Technical Bulletin

Bulletin Number: 429 Revision Number: R-02

SUBJECT: NEW 12oz. CAN STOP SHIM FOR "T" MODEL VENDERS NARROW COLUMNS.
NEW PART NUMBER B497,070,130.83

MODELS: 501T SERIES 90 501T MPC
600T SERIES 90 600T MPC

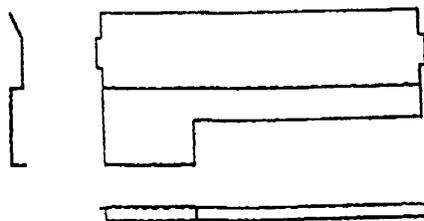
- A. The can retention is increased for the second can (middle) in a narrow column.
- B. The shim prevents the potential for an early delivery of the second can (middle) in a narrow column.

1. Remove existing can stop shim.

2. Install new can stop shim (497,070,130.83).
